Post Approval – Consultation

Post Approval Consultation Record

Jordan Springs Public School

Detailed design road safety audit

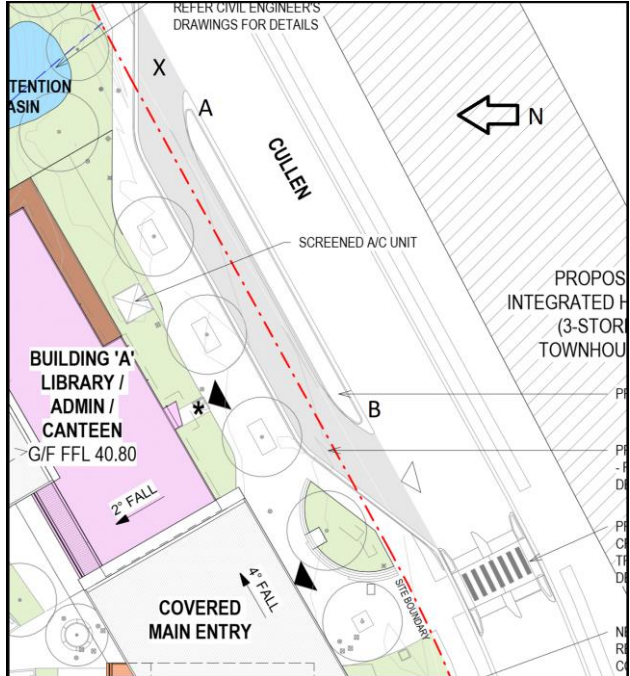
Ref	Location	Road safety audit finding	Priority
1	Pedestrian gates on Lakeside Parade.	There are two pedestrian gates proposed on the Lakeside Parade frontage to the school – labelled X and Y below. These will inevitably generate pedestrian entry/ egress movements. These are also likely to generate demands for road-crossing movements in the midblock. These would mostly be uncontrolled crossing movements requiring the pedestrian to judge and select gaps in the northbound and southbound flows on Lakeside Parade. This would generate <i>vehicle-pedestrian</i> crash conflicts, particularly if school children are involved. Children tend to have poorer peripheral awareness and vigilance when crossing the road. The audit team appreciates that as this is a significant frontage length, pedestrian access points would be a reasonable amenity. As such, to a large extent, these midblock crossing demands will be inevitable. It should be noted that gates X and Y are approximately 200m and 110m (respectively) from the signalised crossing at the Cullen Avenue/ Lakeside Parade/ Water Gum Drive intersection. These distances would impose a severe time-penalty for pedestrians, especially those heading to Crimson Street, Landsborough Street and Pitt Street, as well as the northern portions of Lakeside Parade. The school would need to manage these risks with access-egress strategies and policies. The outbound movements would be relatively easy to manage under teacher supervision. However, the inbound movements involving crossing movements from the western side to the eastern side of the road would be more difficult to prevent. Concepts such as one-way (outbound only) gates could be considered. Alternatively, the gates could simply be locked when there is no ground supervision.  Above: Two pedestrian gates are proposed on the Lakeside Parade frontage which are likely to generate pedestrian crossing demands at these points.	Medium

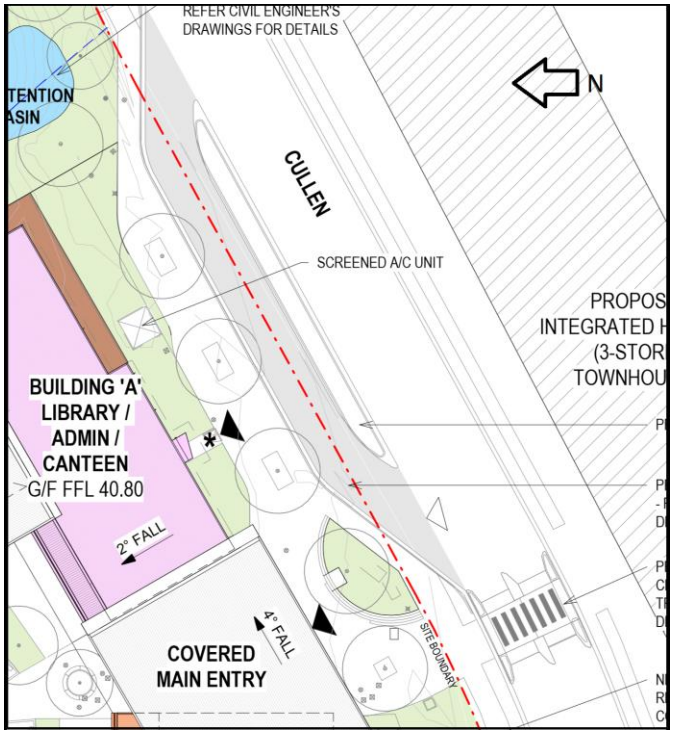
Ref	Location	Road safety audit finding	Priority
2	Vehicle-pedestrian conflicts at the driveways on Lakeside Parade and Cullen Avenue.	The design shows a staff car park on the eastern side of Lakeside Parade and a special needs car park and drop off area on the northern side of Cullen Avenue. Both of these facilities will have inbound-outbound driveways connecting to Lakeside Parade and Cullen Avenue respectively. As the project is still in design phase, there are several opportunities to reduce <i>vehicle-pedestrian</i> conflicts at the driveways. The audit team envisages that the Jordan Springs Town Centre will be a major attractor-generator of pedestrian trips to and from the school. Any pedestrian that emerges from the Lakeside Parade gate and heads towards the Town Centre would need to cross the staff car park driveway as shown by the blue line below. The same applies for the inbound trip in the reverse direction. This presents unnecessary conflicts with vehicles entering and egressing from the driveway. This is especially a risk when there are northbound right-turn movements into the driveway. These drivers would tend to look to the north to check for gaps in the southbound traffic stream and by doing so, may not observe pedestrians walking across the driveway. If there was also a pedestrian gate to the south of the car park driveway (eg. along line A-B-C), this could possibly eliminate such conflicts. Similarly, any pedestrians that emerge from the southern side of the school and head towards the Town Centre would tend to follow the green line. This passes through the special needs car park and driveway. There could be similar <i>vehicle-pedestrian</i> crash risks at this location as well. Similar to above, consideration could be given to providing a pedestrian access along the line A-D-E. Along the same theme of avoiding driveway conflicts, the plan below shows that the 44 bicycle parking spaces would be joined to the staff car park. As such, these cyclists would need to share the driveway with road vehicles which presents unnecessary <i>vehicle-bicycle</i> crash conflicts. Consideration should be given to linking the bicycle parking facility to the adjacent pedestrian walkway. This is indeed the layout shown on plan C04.01.  Left: Extract from the design showing the likely pedestrian walk-trip paths from the western and southern sides of the school due to the large attraction/ generation potential of the Jordan Springs Town Centre.	Medium

Richard Crookes Construction Commentary Given the inevitability of these mid block crossings and severe time penalty that would be imposed by forcing pedestrians to utilise the signalised crossing further south along Lakeside Parade, there is no feasible design resolution to address this issue. Accordingly, this risk will need to be managed by the school's operations team. The project team has considered the pedestrian & vehicle movements along Cullen Avenue and given the location of the proposed wombat crossing on Cullen Avenue, it is anticipated that a majority of the pedestrian traffic wishing to access the school site will utilise this crossing which would not require pedestrian traffic to cross the vehicle traffic utilising the driveway. Additionally the provision of pedestrian link A-D-E would present limited opportunity for passive surveillance by school operations staff and require any pedestrian traffic wishing to utilising the wombat crossing to cross the driveway, increasing the volume of pedestrian traffic making this crossing and the level of risk to pedestrian-vehicle conflict. With regards to the pedestrian movements along Lakeside Parade, the provision of pedestrian link A-B-C is impractical given the location and levels surrounding the existing Endeavour Energy asset on Lakeside Parade. The design now incorporates access to the bike store from the pedestrian gate on Lakeside Parade to avoid the need for bicycle traffic to share the driveway with vehicle traffic. Refer to snap shot below;

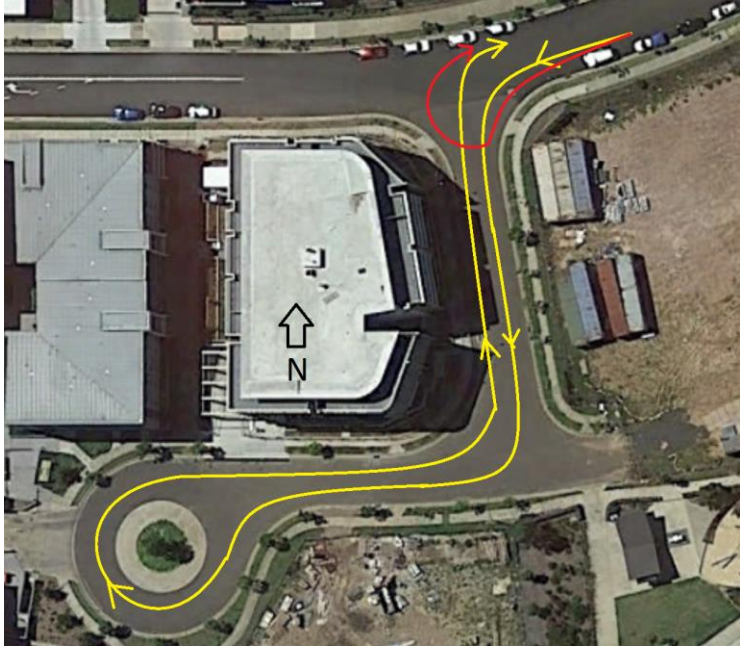
Ref	Location	Road safety audit finding	Priority
3a	Stopping/ parking restrictions on the kerblines – Lakeside Parade at the staff car park.	The plans do not indicate whether there will be any <i>no stopping</i> zones along the Lakeside Parade and Cullen Avenue kerblines. Some critical locations were identified including the staff car park on the eastern side of Lakeside Parade, the special needs car park on the northern side of Cullen Avenue, and the pick up/ drop off bay on the northern side of Cullen Avenue. These have been discussed separately in items 3a, 3b and 3c. <u>Staff car park on the eastern side of Lakeside Parade</u> The staff car park will inevitably generate southbound left-turn movements, and northbound right-turn movements by inbound traffic. Southbound left-turners would tend to slow down when approaching and turning into the car park. If the eastern kerbline allows vehicles to stop or park, then the left-turning vehicle would need to commence the turn from a more central position in the road. This offers little passing opportunity for trailing southbound vehicles. By contrast, if a short <i>no stopping</i> zone is put in place along the eastern kerbline, the left-turning vehicle (red vehicle marked X) could shift to the kerbline and allow trailing vehicles to pass around as indicated by the blue arrow. As such, a <i>no stopping</i> zone should be considered on the eastern kerbline. Similarly, if northbound right-turners (red vehicle marked Y) stop to wait for gaps, any vehicles stopped along the western kerbline would restrict any passing opportunity by other trailing northbound vehicles. If a short <i>no stopping</i> zone is put in place on the western kerbline, trailing southbound vehicles could then use this space to pass around the stopped vehicle (green arrow). The above two scenarios illustrate the value of <i>no stopping</i> zones to improve passing clearance and to reduce <i>rear-end</i> crash potential. Short lengths of <i>no stopping</i> zones either side of the car park driveway would also help to preserve sight lines from the driveway to the north and south. Students and pedestrians moving along the eastern footpath and car park driveway would be less likely to be obscured by parked cars, and hence would be more visible to any drivers turning into the driveway.   Left: Extract from the design showing the criticality of passing opportunities on Lakeside Parade at the staff car park. This could be improved by implementing short lengths of <i>no stopping</i> zones on the eastern and western kerblines. Right: Looking southbound along Lakeside Parade from Crimson Street. Note the kerbside parking demand under pre-existing conditions.	Medium

Ref	Location	Road safety audit finding	Priority
3b	Stopping/ parking restrictions on the kerblines – <i>Special needs</i> car park on the northern side of Cullen Avenue. Continued from item 3a...	Continued from item 3a... <u><i>Special needs</i> car park on the northern side of Cullen Avenue</u> The <i>special needs</i> car park on the northern side of Cullen Avenue will inevitably generate eastbound left-turn movements into the car park. If vehicles are allowed to stop along the northern kerbline of Cullen Road, the left-turning vehicle would be forced to take a more central position in the roadway. This would limit any passing opportunity by trailing eastbound vehicles. Any passing attempt could also generate <i>head-on</i> crash risks with westbound vehicles. By contrast, if a short length of <i>no stopping</i> zone is put in place on the western side of the driveway, the left-turning vehicle could shift to the north (green vehicle in left-hand image). This would allow eastbound trailing vehicles to pass around the slowed vehicle without encroaching into the westbound lane. Also, a <i>no stopping</i> zone would also improve sightlines of drivers egressing from the driveway. This is especially since the driveway will be located midway along a horizontal curve, and on the inside of the curve. The combined effect of the horizontal curvature of the road and vehicles stopped along the northern kerbline may reduce the <i>minimum gap sight distance</i> (MGSD) from the driveway. This is the sight line needed by egressing drivers to view approaching traffic streams, judge gaps and then enter those traffic streams. The potentially restricted MGSD sight line may lead to <i>cross traffic</i> crashes. Left: Extract from the design showing the proposed layout of the <i>special needs</i> car park on the northern side of Cullen Avenue. Right: Looking eastbound along Cullen Avenue showing the kerbside parking demands under pre-existing conditions. Note also the impact of the horizontal curve and parked cars, on the sight line between eastbound drivers and the future driveway, and vice versa.	Medium

3a	Stopping/ parking restrictions on the kerblines – Lakeside Parade at the staff car park.	The plans do not indicate whether there will be any <i>stopping</i> zones along the Lakeside Parade and Cullen Avenue kerblines. Some critical locations were identified including the staff car park on the eastern side of Lakeside Parade, the special needs car park on the northern side of Cullen Avenue, and the pick up/ drop off bay on the northern side of Cullen Avenue. These have been discussed separately in items 3a, 3b and 3c. Staff car park on the eastern side of Lakeside Parade The staff car park will inevitably generate southbound left-turn movements, and northbound right-turn movements by inbound traffic. Southbound left-turners would tend to slow down when approaching and turning into the car park. If the eastern kerbline allows vehicles to stop or park, then the left-turning vehicle would need to commence the turn from a more central position in the road. This offers little passing opportunity for trailing southbound vehicles. By contrast, if a <i>shorto stopping</i> zone is put in place along the eastern kerbline, the left-turning vehicle (red vehicle marked X) could shift to the kerbline and allow trailing vehicles to pass around as indicated by the blue arrow. As such, a <i>no stopping</i> zone should be considered on the eastern kerbline. Similarly, if northbound right-turners (red vehicle marked Y) stop to wait for gaps, any vehicles stopped along the western kerbline would restrict any passing opportunity by other trailing northbound vehicles. If a <i>shorto stopping</i> zone is put in place on the western kerbline, trailing southbound vehicles could then use this space to pass around the stopped vehicle (green arrow). The above two scenarios illustrate the value of <i>stopping</i> zones to improve passing clearance and to reduce <i>rear-end</i> crash potential. Short lengths of <i>no stopping</i> zones either side of the car park driveway would also help to preserve sight lines from the driveway to the north and south. Students and pedestrians moving along the eastern footpath and car park driveway would be less likely to be obscured by parked cars, and hence would be more visible to any drivers turning into the driveway. Below: Extract from the design showing the criticality of passing opportunities on Lakeside Parade at the staff car park. This could be improved by implementing short lengths of <i>no stopping</i> zones on the eastern and western kerblines. Right: Looking southbound along Lakeside Parade from Crimson Street. Note the kerbside parking demand under pre-existing conditions. 	Medium	The recommended no stopping zones have been implemented in conjunction with a number of bus zones - refer to LTC approved drawings for further information

3b	Stopping/ parking restrictions on the kerblines – <i>Special needs</i> car park on the northern side of Cullen Avenue. Continued from item 3a...	Continued from item 3a... <i>Special needs</i> car park on the northern side of Cullen Avenue The <i>special needs</i> car park on the northern side of Cullen Avenue will inevitably generate eastbound left-turn movements into the car park. If vehicles are allowed to stop along the northern kerbline of Cullen Road, the left-turning vehicle would be forced to take a more central position in the roadway. This would limit any passing opportunity by trailing eastbound vehicles. Any passing attempt could also generate <i>head-on</i> crash risks with westbound vehicles. By contrast, if a short length of <i>stopping</i> zone is put in place on the western side of the driveway, the left-turning vehicle could shift to the north (green vehicle in left-hand image). This would allow eastbound trailing vehicles to pass around the slowed vehicle without encroaching into the westbound lane. Also, a <i>no stopping</i> zone would also improve sightlines of drivers egressing from the driveway. This is especially since the driveway will be located midway along a horizontal curve, and on the inside of the curve. The combined effect of the horizontal curvature of the road and vehicles stopped along the northern kerbline may reduce the <i>minimum gap sight distance</i> (MGSD) from the driveway. This is the sight line needed by egressing drivers to view approaching traffic streams, judge gaps and then enter those traffic streams. The potentially restricted MGSD sight line may lead to <i>cross traffic</i> crashes. Below Left: Extract from the design showing the proposed layout of the <i>special needs</i> car park on the northern side of Cullen Avenue. Below Right: Looking eastbound along Cullen Avenue showing the kerbside parking demands under pre-existing conditions. Note also the impact of the horizontal curve and parked cars, on the sight line between eastbound drivers and the future driveway, and vice versa. 	Medium	The recommended no stopping zones have been implemented in conjunction with a number of bus zones - refer to LTC approved drawings for further information

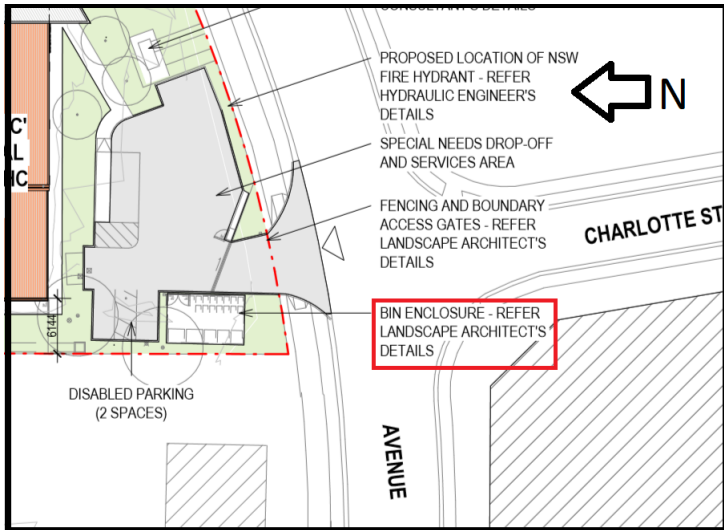
Ref	Location	Road safety audit finding	Priority
3c	Stopping/ parking restrictions on the kerblines –Pick up/ drop off bay on the northern side of Cullen Avenue. Continued from item 3b...	Continued from item 3b... <u>Pick up/ drop off bay on the northern side of Cullen Avenue</u> The kerline adjacent to the pick up/ drop off bay (marked A-B below) would also need to be signposted as a <i>no stopping</i> zone. This is to preserve sight lines from the egress point at X to the west. That is, any vehicles stopped along this kerline could block the <i>minimum gap sight distance</i> (MGSD) sight line from the egress point to the west. Also, if vehicles are allowed to stop along this kerline, it may be mis-used by parents/ carers when picking up children. These drivers may consciously avoid entering the pick up bay and joining its queue. They may resort to waiting on kerline A-B. This is especially undesirable as it would encourage students to cross the pick up bay with risks of impacts by vehicles moving along this facility. Also, the students would be forced to wait and board/ alight the vehicle from the narrow traffic island between the pick up/ drop off bay and Cullen Avenue.  <i>Left: Extract of the design showing the proposed layout of the pick up/ drop off bay.</i>	Medium

3c	Stopping/ parking restrictions on the kerblines –Pick up/ drop off bay on the northern side of Cullen Avenue. Continued from item 3b...	Continued from item 3b... Pick up/ drop off bay on the northern side of Cullen Avenue The kerblines adjacent to the pick up/ drop off bay (marked A-B below) would also need to be signposted as no stopping zone. This is to preserve sight lines from the egress point at X to the west. That is, any vehicles stopped along this kerblines could block the minimum gap sight distance (MGSD) sight line from the egress point to the west. Also, if vehicles are allowed to stop along this kerblines, it may be mis-used by parents/ carers when picking up children. These drivers may consciously avoid entering the pick up bay and joining its queue. They may resort to waiting on kerblines A-B. This is especially undesirable as it would encourage students to cross the pick up bay with risks of impacts by vehicles moving along this facility. Also, the students would be forced to wait and board/ alight the vehicle from the narrow traffic island between the pick up/ drop off bay and Cullen Avenue. Below: Extract of the design showing the proposed layout of the pick up/ drop off bay. 	Medium	The recommended no stopping zones have been implemented in conjunction with a number of bus zones - refer to LTC approved drawings for further information
